Vernon-Sicilian House & 21 Southampton Row

Conservation Officer Comments - HBA Response
December 2022

This document has been prepared in order to address some of the comments received by the London Borough of Camden's Conservation and Heritage team on 9 November, 2022, regarding the proposed refurbishment works to Vernon and Sicilian House and 21 Southampton Row, which constitute Project 1 of the Holborn Links Estate.

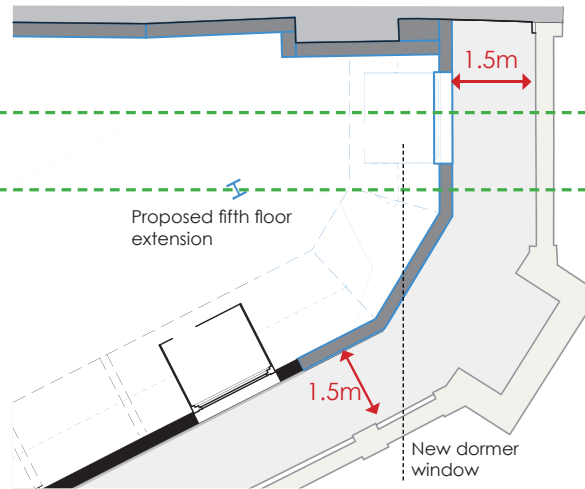
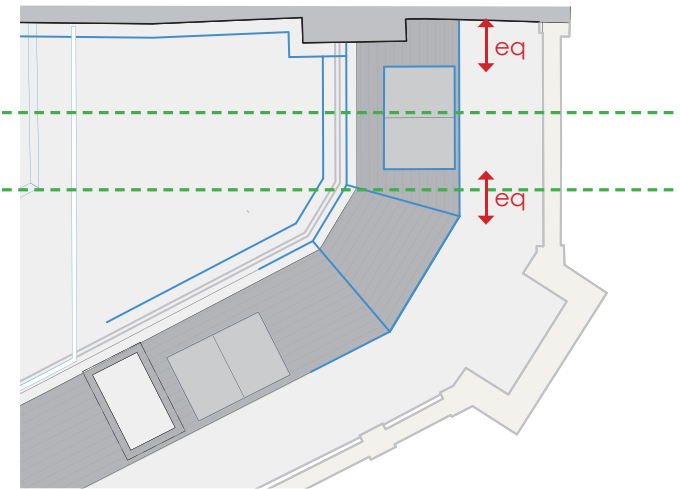
'At the roof level extension, can the window be repositioned to respond to the fenestration below.'

- The proposed 5th floor extension looks to infill the overshadowed and under used terrace space overlooking Bloomsbury Square
- To maintain the set back of the existing roof the new mansard would have a faceted corner
- Due to this configuration it is not feasible to position the proposed dormer window to align with the windows on the floors below when viewed square on
- Currently the dormer is positioned to sit centrally within its section of the sloping roof
- For the dormer window to align it would be necessary to increase the size of the extension reducing the set back
- If the window width was reduced to enable it to be centred on the windows below, it would require a reduction in width by almost half. This would probably also mean a change to its opening action, from a double casement to a single casement, making it inconsistent with the other dormers on the roof.
